Addendum No.1, IFB 16-16

To: Prospective bidders **IFB 16-16**, Otis Street Playground Renovation
From: Alex Nosnik, Assistant Director, Purchasing
Date: 9/1/2015

Addendum No. 1 to IFB 16-16

L-5.0, Utilities Plan:

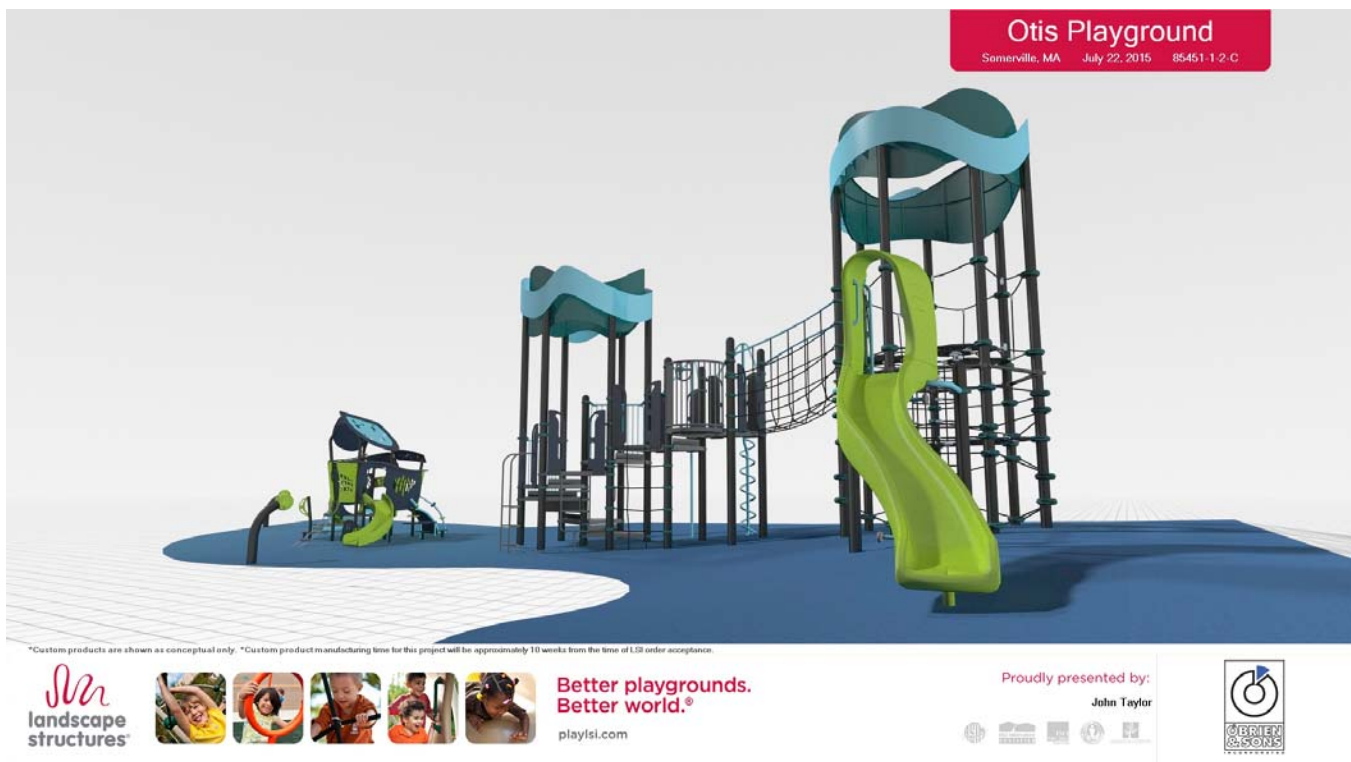
11. The "Conduit in Risers for Rope Light (Typ)" callout points to an incorrect location on the plans; the conduit riser locations are indicated by the small circles at the ends of the —E— lines leading to the walls, set toward the center of the wall. Also, please note that all LED Rope Light and related conduits are Alternate #2.
